TECHNICAL NOTE

WINGS NURSERY, LIDSEY ROAD, WOODGATE, WEST SUSSEX

Response to West Sussex County Council Highway Comments.

Ref: ADMA/17/3711s

Plan No: Plan 01	Job No: 3711	Date: June 17	Scale: NTS
Drawn By: EJD	Checked By: ALS	Approved By: PMR	Rev: -

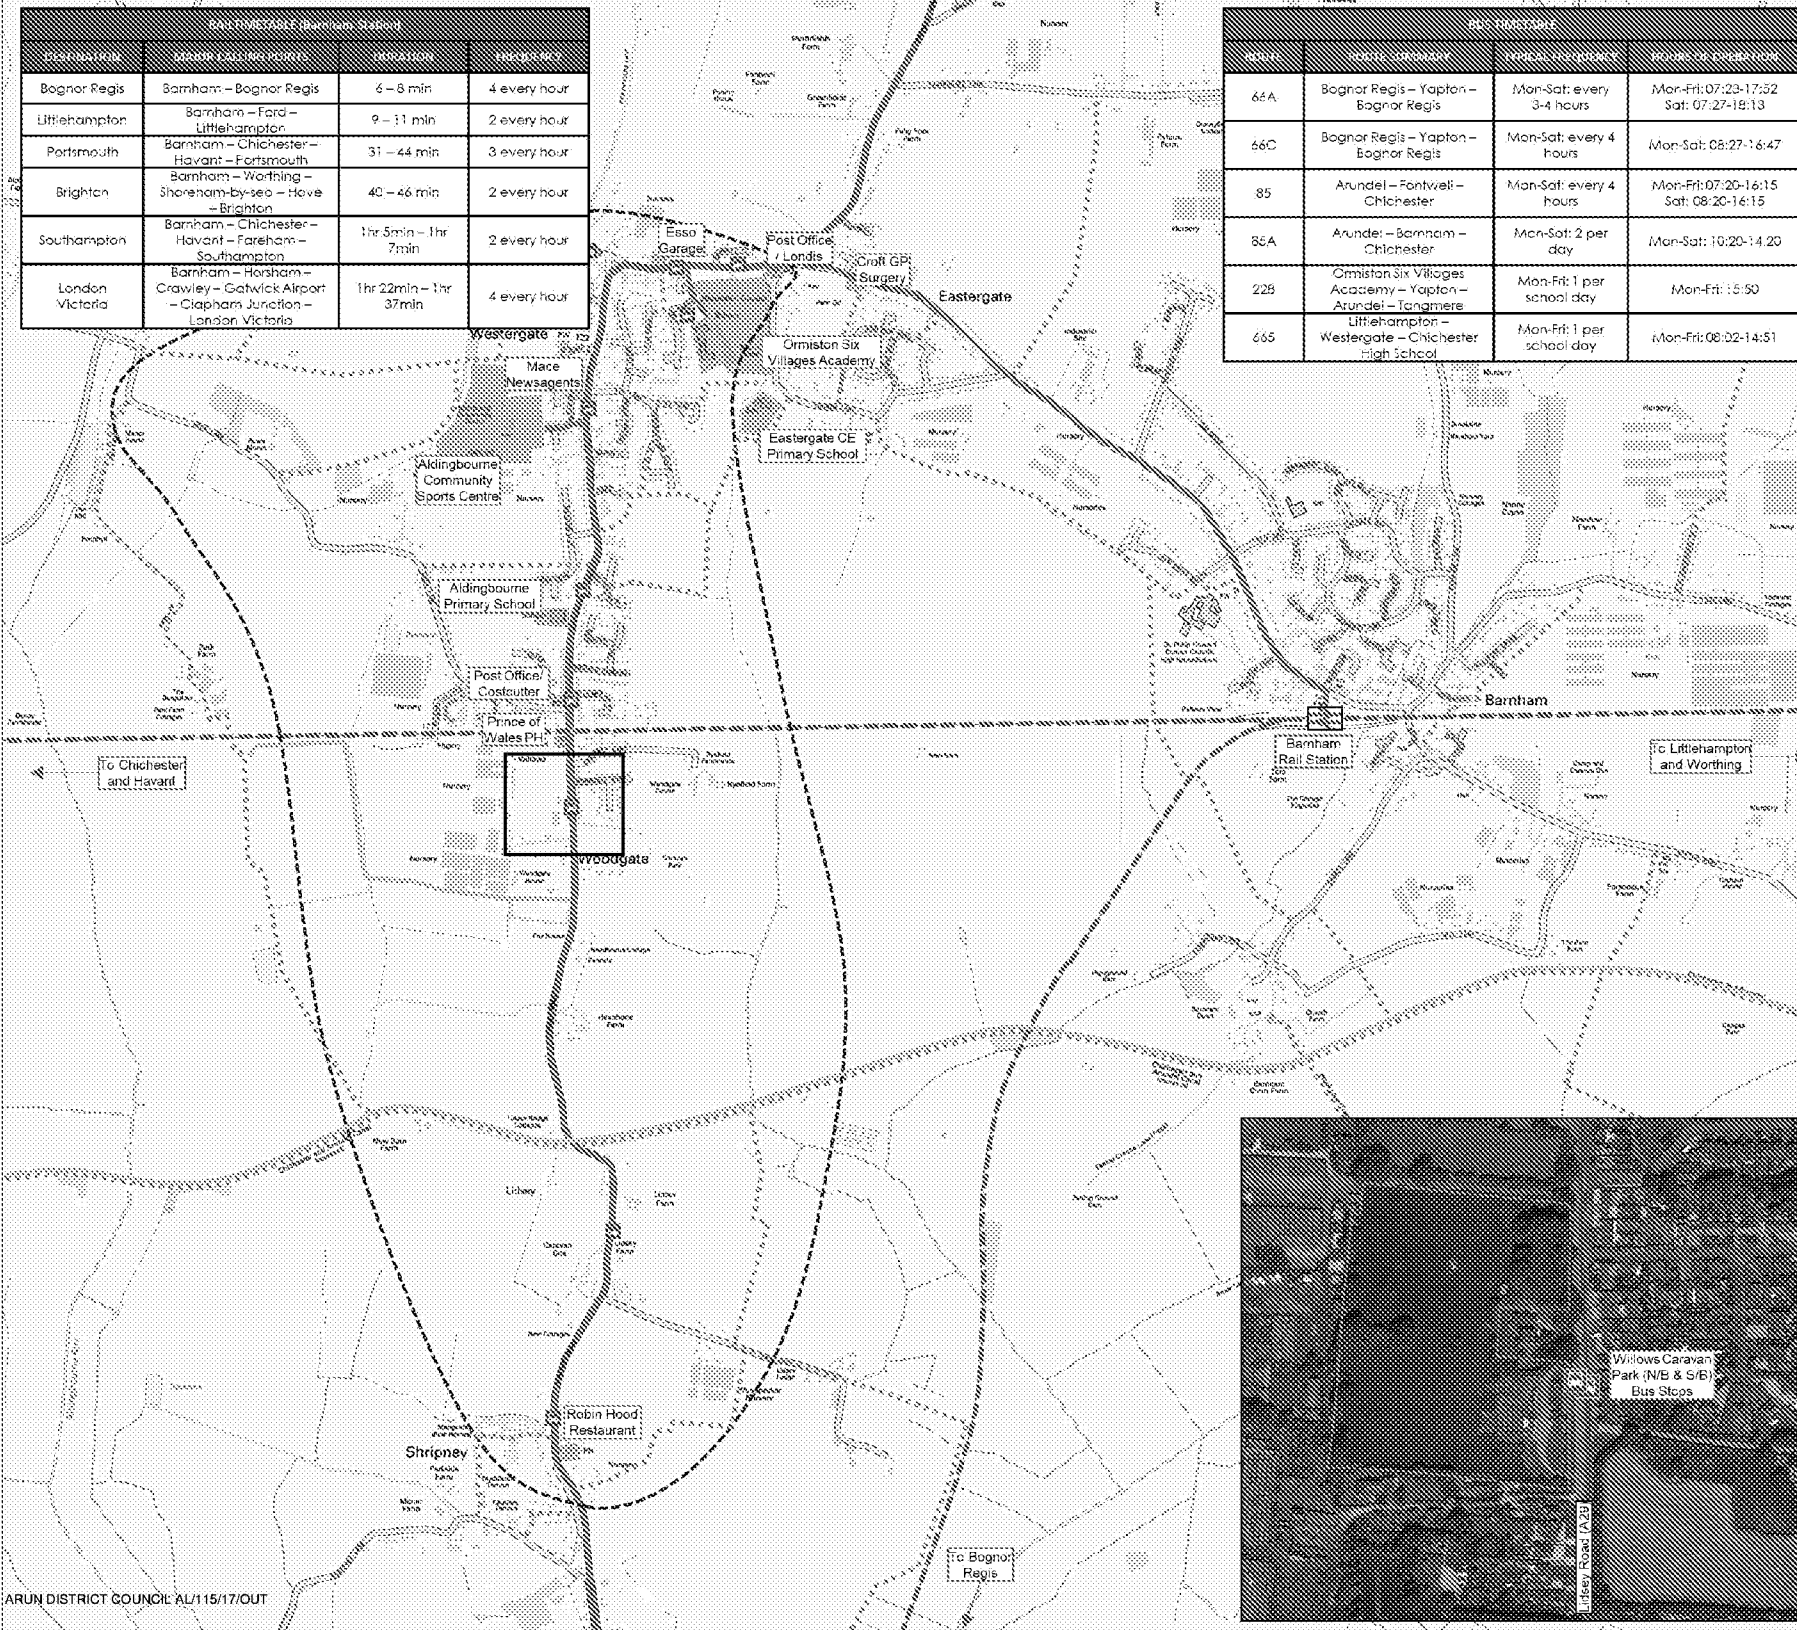
The development site is located in the village of Woodgate which forms the southern part of an almost continuous ribbon development northwards along the A29 and eastwards along the B2223 comprising the villages of Westergate, Eastergate and Barnham. It is remote from existing major employment centres in Bognor Regis, Chichester and Littlehampton although there are a number of smaller local employment centres in the aforementioned villages. In terms of transport sustainability, the site is not well located being on the edge of the settlement boundary and remote from the nearest railway station at Barnham. The level of bus service passing the site is also limited and the main cycle and pedestrian routes are along the busy A29. Cyclists have to share limited road space with other traffic. Pedestrians have to walk adjacent to traffic along the main road – in places where footways are narrow – and have no assisted ways to cross the A29 which if provided, could provide some access opportunities to formal Public Rights of Way (PRoW) leading towards Barnham and its railway station.

Given the above, there is again conflict with the NPPF. The lack of suitable pedestrian facilities was identified previously by the Highway Authority in connection with the previous Woodgate Centre planning applications and reiterated at the subsequent Planning Appeals. This was acknowledged by the Inspectors when considering the latter.

- 2.21 In the immediate vicinity of the site the existing community is supported by convenience facilities, local schools, and leisure facilities. As demonstrated in Plan 01 (attached) the site provides pedestrian and cycle connectivity to these services. The applicant is happy to cooperate in providing crossing facilities as required by the LHA, where cost effective and the level of mitigation offered is justified.

Swept Path Analysis and Visibility Splays

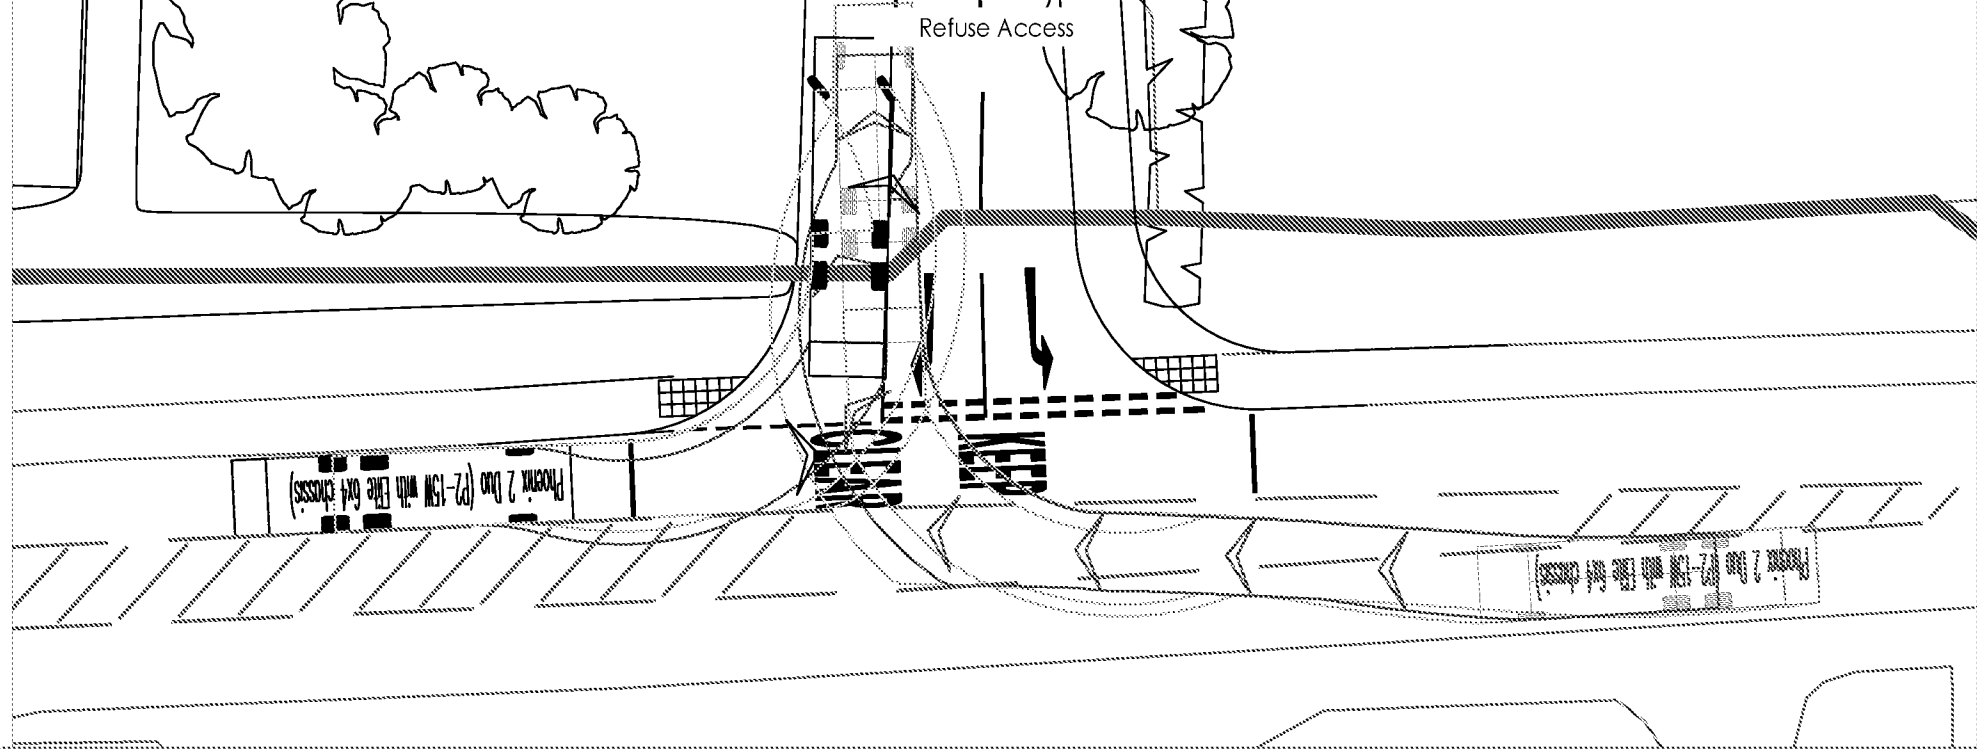
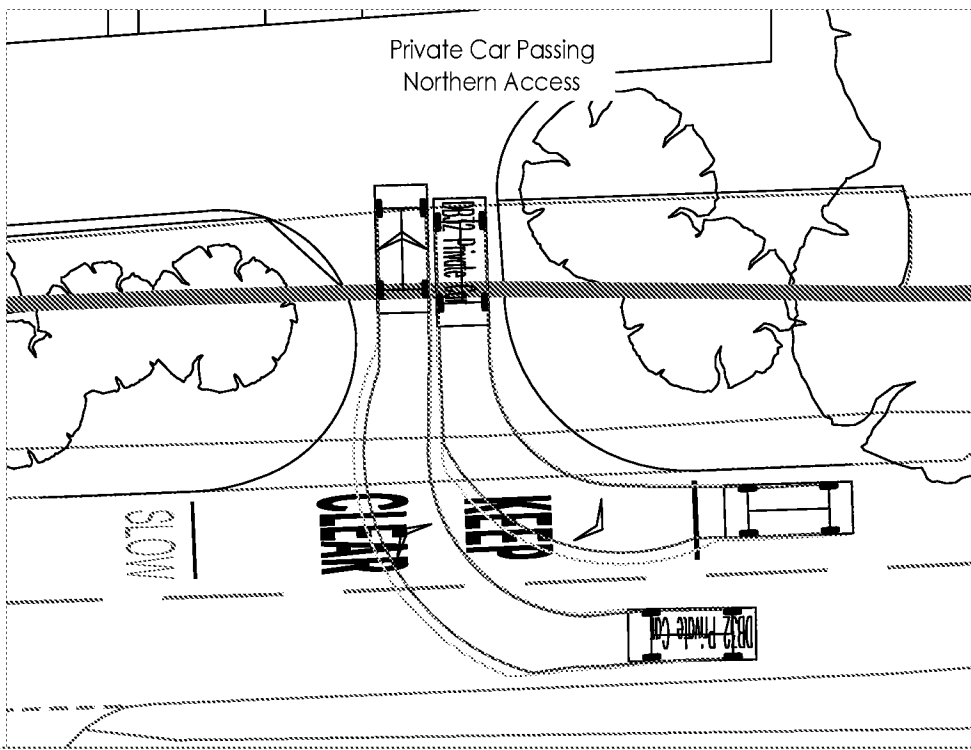
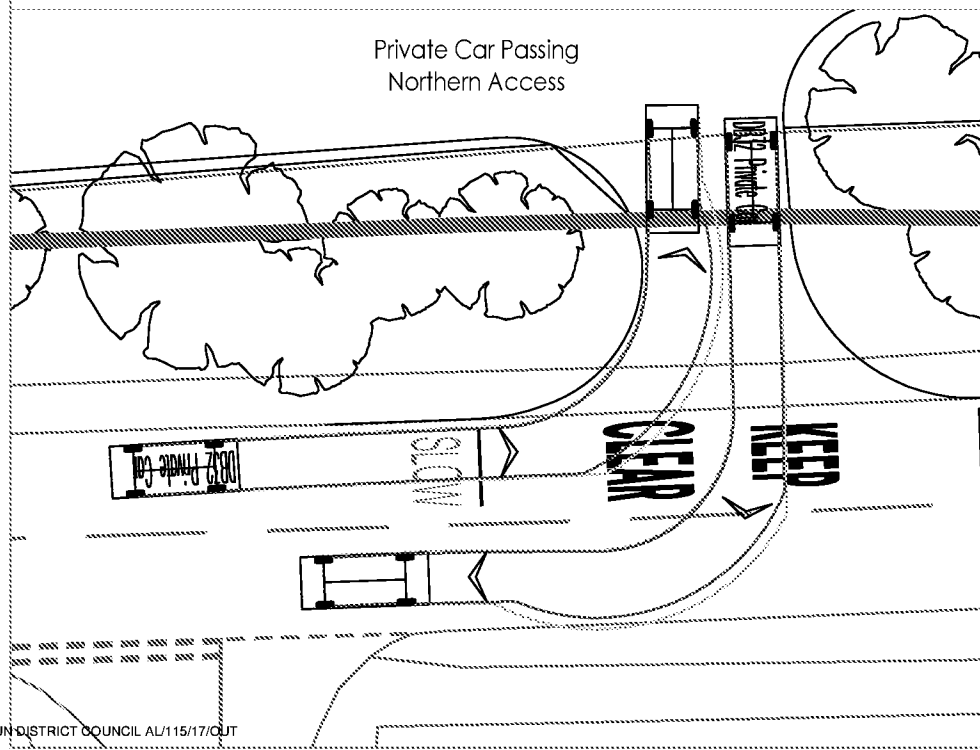
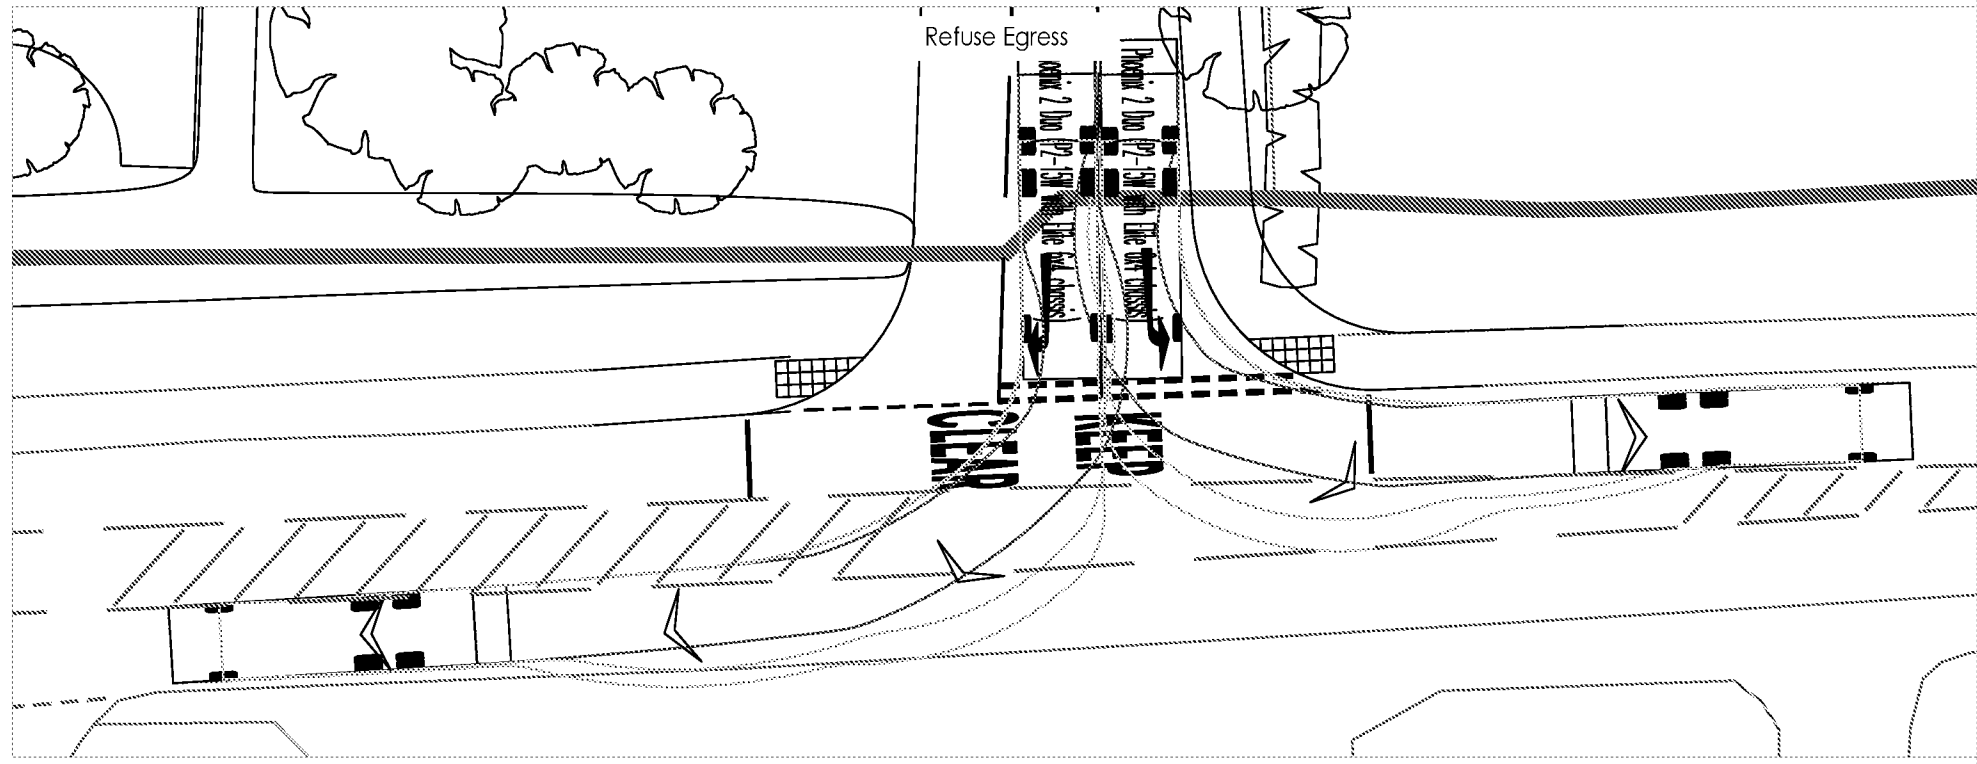
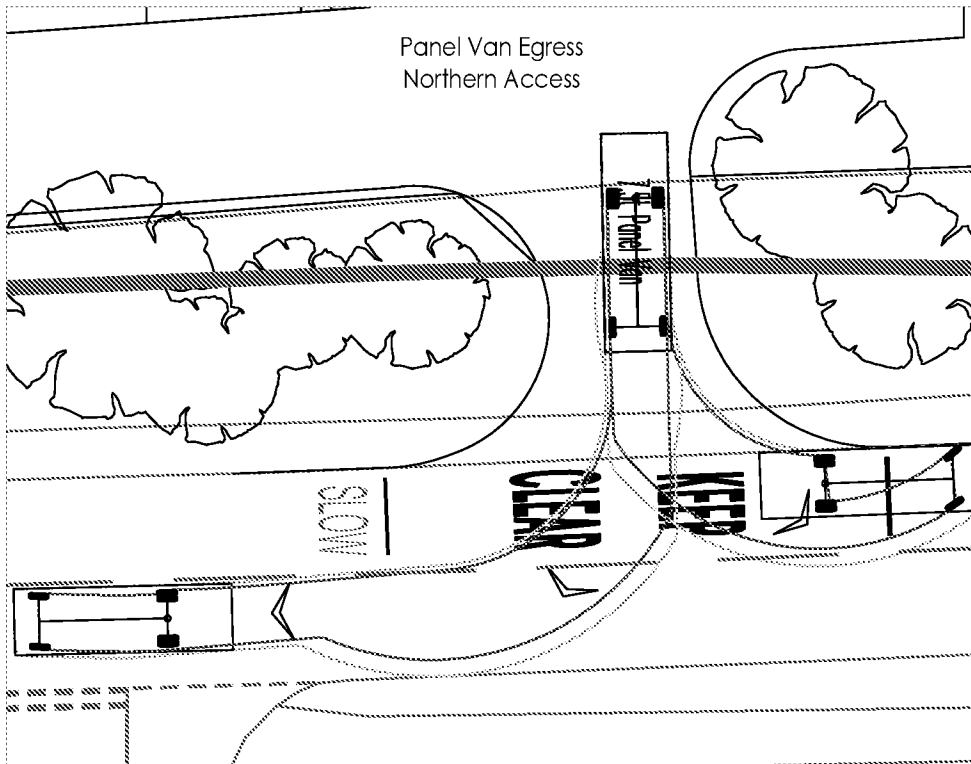
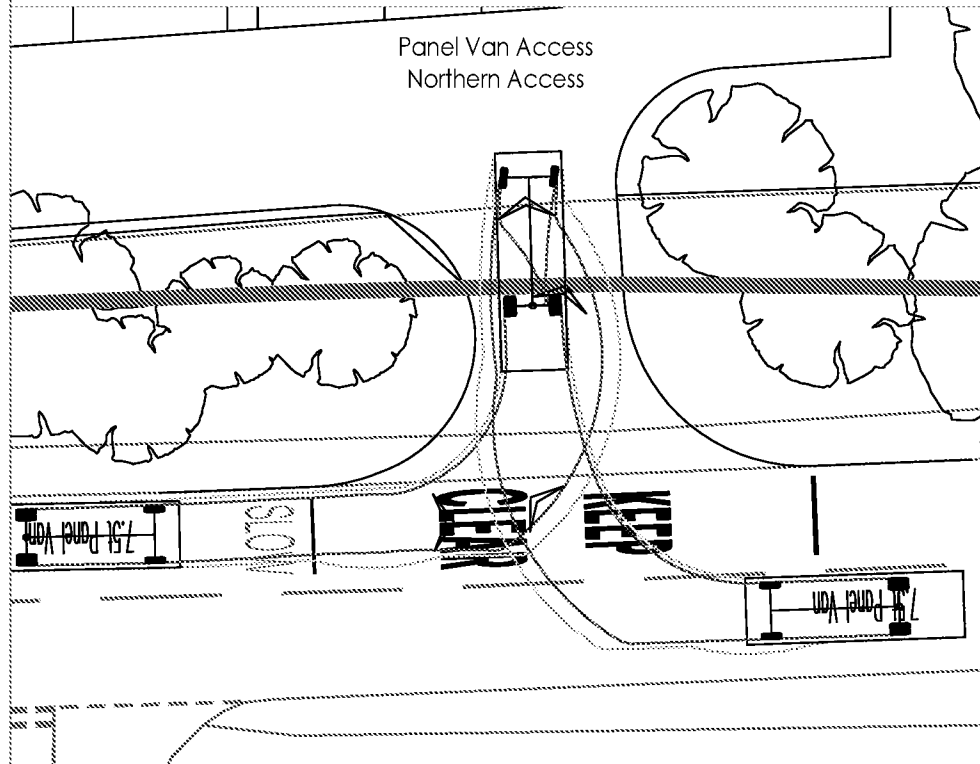
The proposed access arrangements comprise two junctions – one serving 4 dwellings in the form of a shared private drive with the other one a more formalised road junction with footways running either side. The latter (referred to herein as the 'primary access') has a single lane approach to the A29 Lidsey Road. Residents of the new estate, when emerging, would have to wait at the junction to turn left (northbounds) out of Woodgate Close onto the A29 if a queue of traffic resulting from the railway crossing prevailed. Only when such queuing dissipated, could drivers easily emerge. Drivers wanting to turn right (southbounds) might experience frustration being blocked by the left turners and/or traffic queue. In such circumstances it is likely that right turning drivers may choose to circumvent the waiting driver and use the opposing lane at the junction. This has been observed at Woodgate Road and neighbouring roads. This increases the safety risk should any vehicle co-incidentally be turning into the junction from the A29. While the traffic impact appears modest given the number of dwellings proposed, any blocking-back would create delays leading to emerging vehicles queueing within the estate.

3. No 'KEEP CLEAR' markings shown on the A29 (although it is noted that the Stage 1 Road Safety Audit supplied with the application makes mention of this). Although this might – in part - assist with attempting to overcome the issues raised in 1 and 2 above, it would not fully resolve the issue.

A Stage 1 Road Safety Audit accompanies the planning application, prepared by the Safety Forum (September 2017). Three problems have been identified, a summary of which is provided below (full details can be read in the Transport Statement prepared by RGP Highways and Traffic Consultants):

1. Drainage at the proposed/upgraded point of access
2. Design of tactile paving at junction
3. Trees north of access obscuring visibility for emerging vehicles

In the Designer's Response, the applicant appears to agree with all the recommendations. However, no explanation of how the recommendations would be achieved is offered. Until such time as the designer provides appropriate replies and further information, the Highway Authority is not satisfied the Audit recommendations have been accepted.

- 2.2 It is consider unlikely that this manoeuvre would be ordinarily attempted and therefore not a material safety concern. Highways design cannot take account for anomalous driving behaviour. The PIA incident data reveals a single incident associated with a similar manoeuvre, this is however a standalone incident that cannot be considered statistically significant. To enable right turns out of the site and avoid any perceived issues associated with potential flow restriction we have shown a right turn exit lane in the attached drawings.

- 2.6 The recommended measures within the Stage 1 Road Safety Audit have been accepted and changes accordingly made to the access as demonstrated in the attached drawings.

- 2.10 The recommended measure in the Stage 1 Road Safety Audit has been accepted and identified in the attached drawings.

- 2.14 The Stage 1 Road Safety Audit's standard designer's response identifies solutions to the problems raised, which in this case have all been accepted. The recommendations have where possible been shown within the attached drawings. The designer's response only requires description of alternative measures where the designer is proposing a different mitigating solution to that proposed within the Stage 1 Road Safety Audit.
